NJDEP Oyster Creek Drywell Review

Document No. 17693-R-001

Revision No. 0 (4/6/2009)

Figure 3.2
Modified Capacity Reduction Factor for Tensile Hoop Stress (Fig. 8-7a of SIA's 403 Report [1])

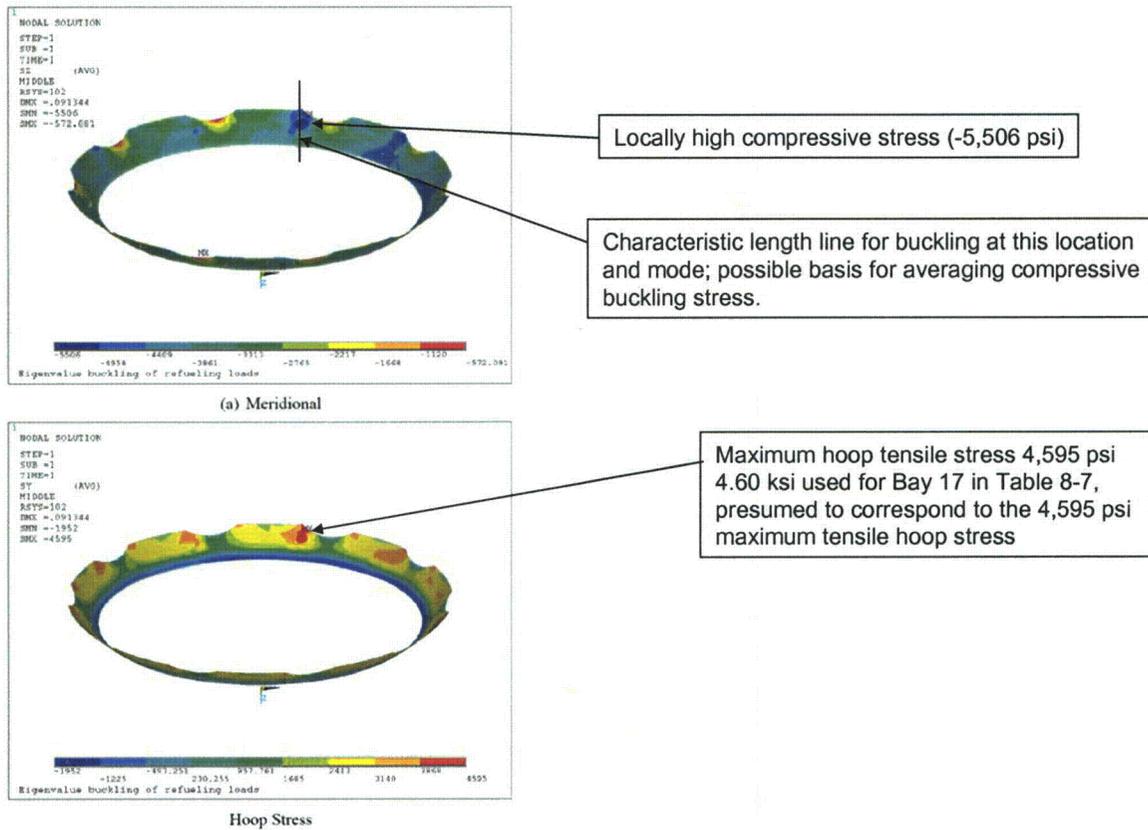
3.2 Modified Capacity Reduction Factor Comment. Figures 3.2 and 3.3 are provided as a supplement to the comment on Section 8.3 of the 403 Report [1] from Table 2.3.

Figure 3.2 shows a case where the maximum compressive and maximum tensile stresses are approximately at the same location. Both the compressive stress and hoop tensile stresses are high (absolute values) in a local region – the blue circular region and the red circular region in Fig. 3.2. BNS believes that such a condition is not one that clearly justifies the use of the hoop tensile stress modified CRF, as SIA has done. Nonetheless, it may be possible to define an appropriate local characteristic length to mitigate the effects of taking the locally highest value of compressive stress. A portion of that line may be used over which to average compressive buckling stress. Similarly, it may be possible to define an appropriate hoop-direction local characteristic length to assure that an adequate region of hoop tension exists to provide the purported benefits of hoop tension on the CFR.

The use of Miller's modified capacity reduction factor [23] for the refueling case is not appropriate for all locations as explained in Section 3.2. However, when the modified factors are not used (more conservative), the resulting buckling safety factors meet N-284-1 [24].

Figure 3.3
Modified Capacity Reduction Factor for Tensile Hoop Stress (Fig. 8-9a of SIA's 403 Report [1])

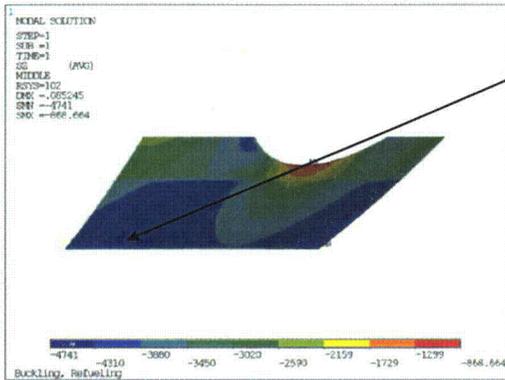
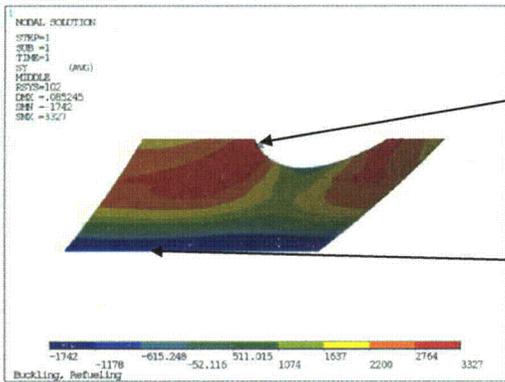
Figure 3.3 shows a case where the maximum compressive and maximum tensile stresses are not at the same location, which BNS believes would not qualify for using the modified Miller equation [23].
